Mobile Pentium® II Processor Specification Update

Release Date: November 1999

Order Number: 243887-015

The Mobile Pentium® II processor or the Intel® Pentium® II Processor Mobile Module may contain design defects or errors known as errata which may cause the product to deviate from published specifications. Current characterized errata are documented in this Specification Update.

OLD MOBILE PENTIUM® II PROCESSOR IN MINI-CARTRIDGE PACKAGE LABEL WITH SUPPLIER MATRIX MARK

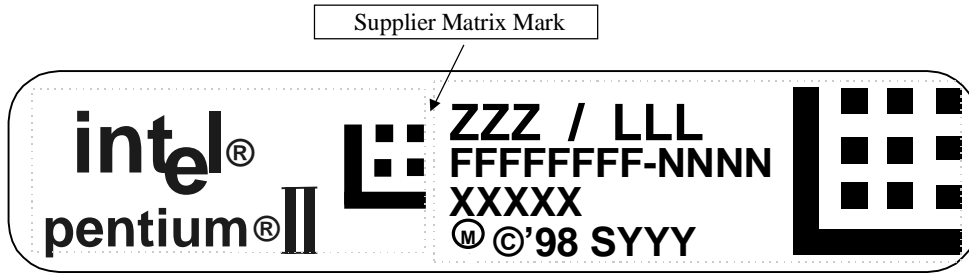
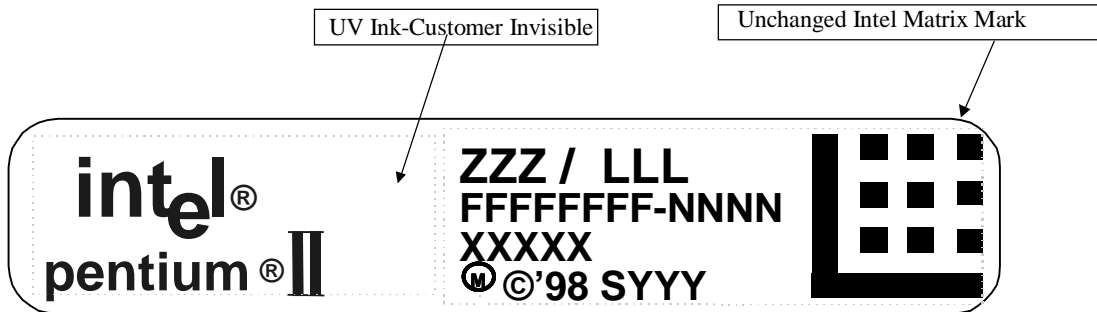
NEW MOBILE PENTIUM® II PROCESSOR IN MINI-CARTRIDGE PACKAGE LABEL WITH SUPPLIER MATRIX MARK REMOVED

Figure 2. Workaround Flowchart: SMBALERT#-Driven System

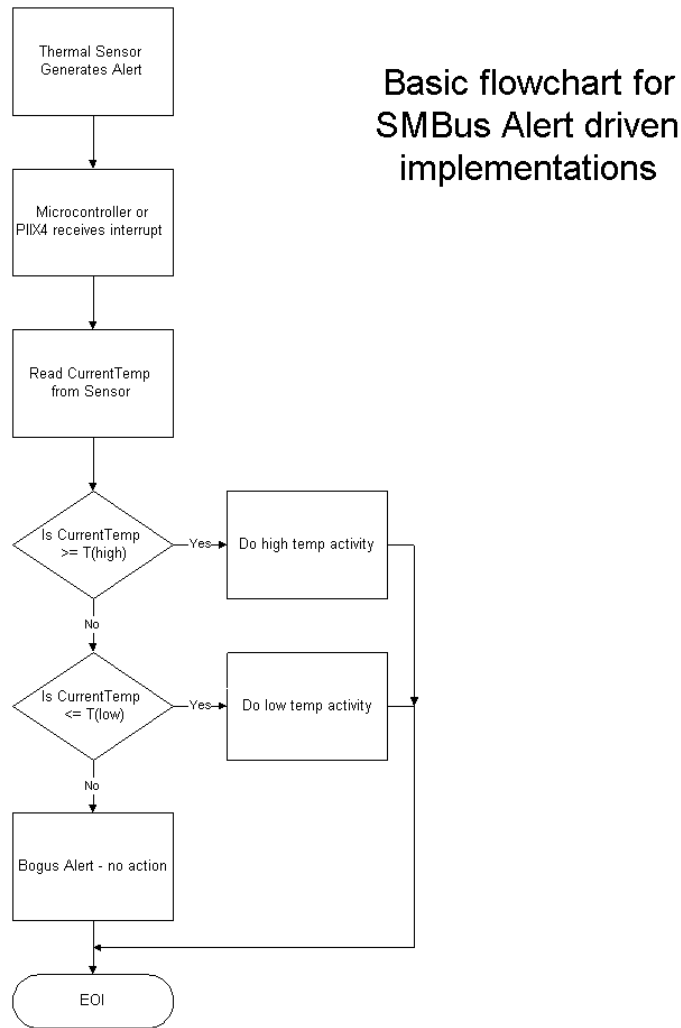
B30. Thermal Sensor May Assert SMBALERT# Incorrectly

Under the conditions described below, the thermal sensor incorrectly generates the SMBALERT# interrupt. All of the following conditions must be met to trigger a false interrupt:

1. Before servicing an interrupt from the thermal sensor, read and compare the processor thermal reading with the threshold limits (T_{HIGH} or T_{LOW}). Figures 2 and 3 provide basic flowcharts for the implementation of this workaround in an interrupt driven system.
2. If the firmware implemented polls the Status Register only, then before taking any action, re-read the temperature register and do a comparison with the alarm threshold limits (T_{HIGH} or T_{LOW}) to determine if the value is actually still within the temperature window.

- Use a temperature polling scheme to monitor the processor temperature.

Figure 5.6. Cross Sectional View with Vertical Dimensions

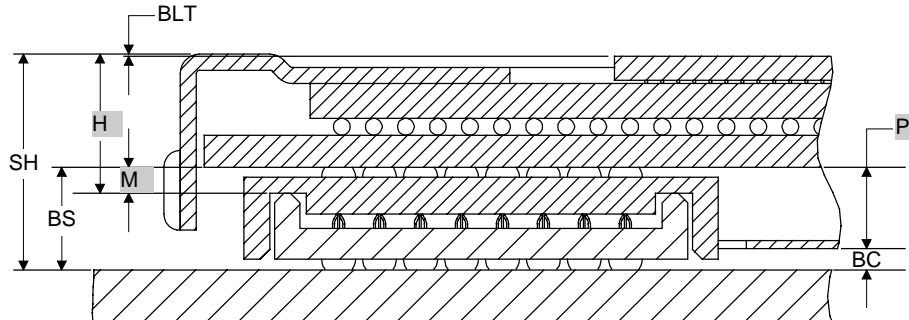
B1. Mislabeled Vertical Dimension Parameters

Figure 5.6 in the *Mobile Pentium® II Processor at 233 MHz, 266 MHz, and 300 MHz* datasheet should be replaced by the following figure:

Figure 5.3. Surface-Mount BGA1 Package—Top and Side View

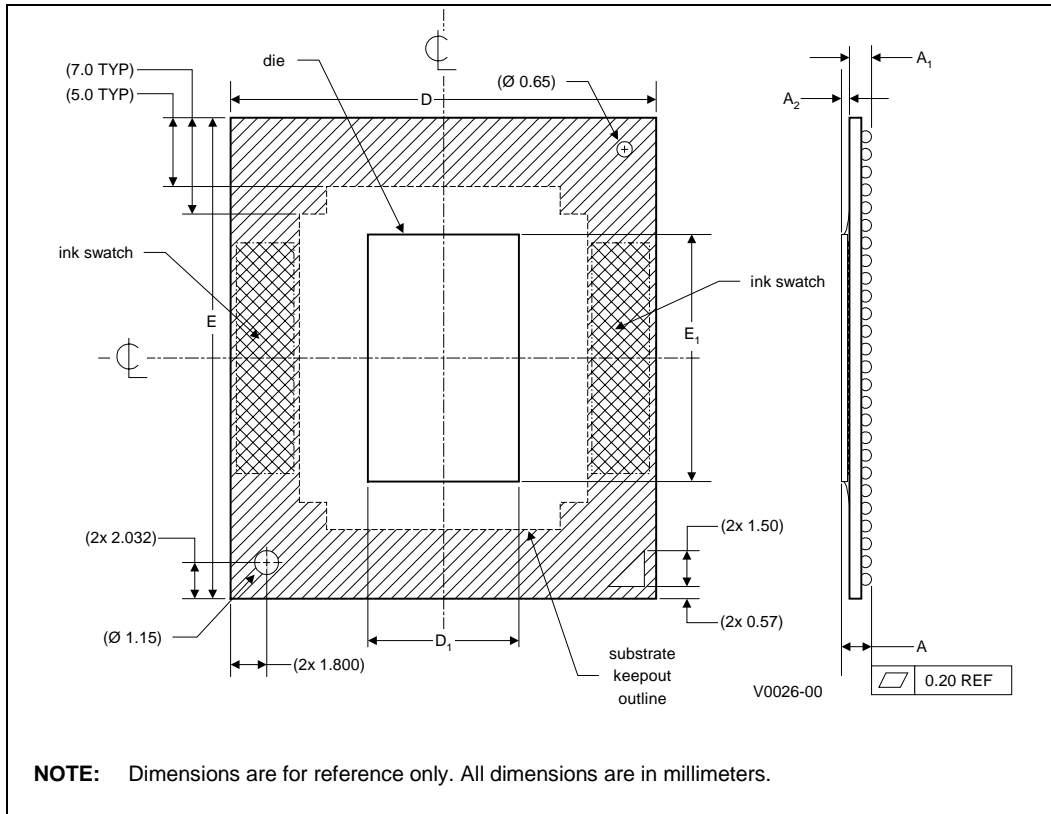
The following table and figures show the updated mechanical specifications for the BGA1 package, listed as Table 5.2, Figure 5.3 and Figure 5.4, respectively, in the *Mobile Pentium® II Processor in BGA Package at 366 MHz, 333 MHz, 300PE MHz, and 266PE MHz* datasheet.

1. The number shown here is different from that in the 243887-010 revision of this specification update. The maximum reference number is used.

Figure 3.3 Generic Clock Waveform

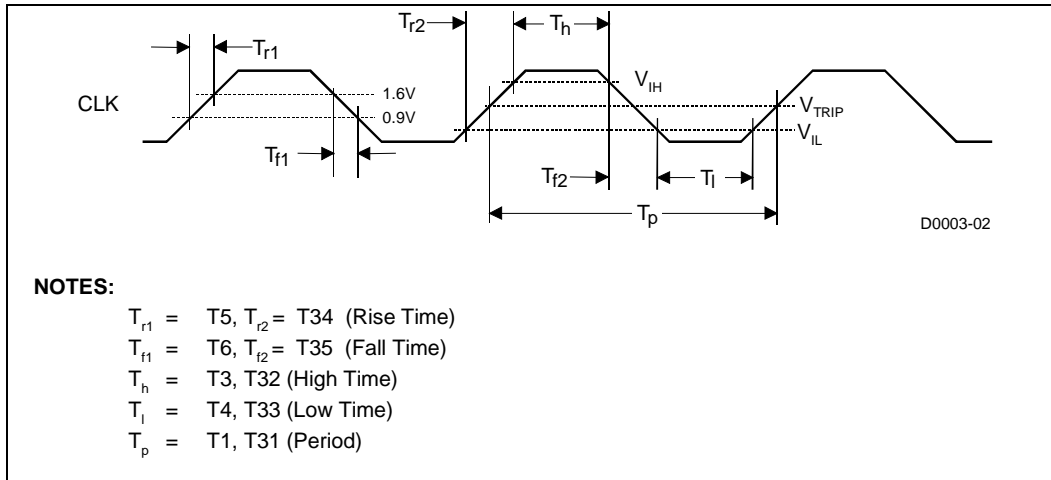
B14. Generic Clock Waveform Figure

Figure 3.3 in *Mobile Pentium® II Processor in Mini-Cartridge Package at 366 MHz, 333 MHz, 300PE MHz, and 266PE MHz* datasheet (Order Number 245108), and the *Mobile Pentium® II Processor in BGA Package at 366 MHz, 333 MHz, 300PE MHz, and 266PE MHz* datasheet (Order Number 245106) has been updated. The following figure is to replace the ones in the above documents.

Figure 1. TAP Gageable Thread Clarification

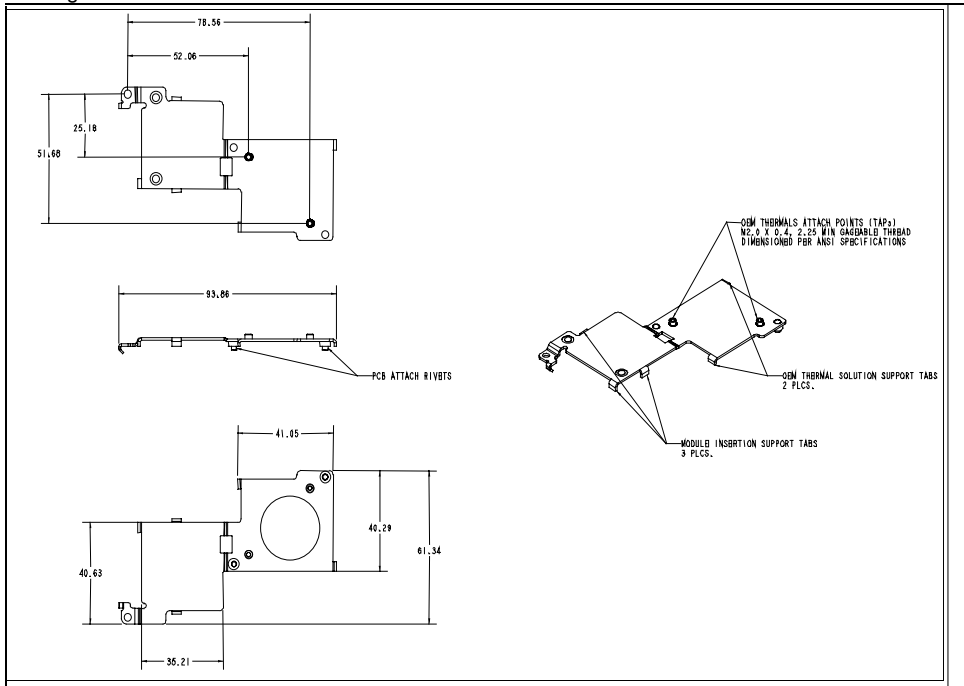
In the *Intel® Pentium® II Processor Mobile Module : Mobile Module Connector 1 (MMC-1)* and the *Intel® Pentium® II Processor Mobile Module : Mobile Module Connector 2 (MMC-2)* datasheets (Order Numbers 243667 and 243668, respectively), the thermal attach point (TAP) gageable thread specification was not clearly identified in Figure 14, of Section 5.2. The following is the TAP clarification:

See Figure 1 below for more information.

OEM Thermal Attach Points (TAPs) M2.0 x 0.4, 2.25 min gageable thread dimensioned per ANSI specification.
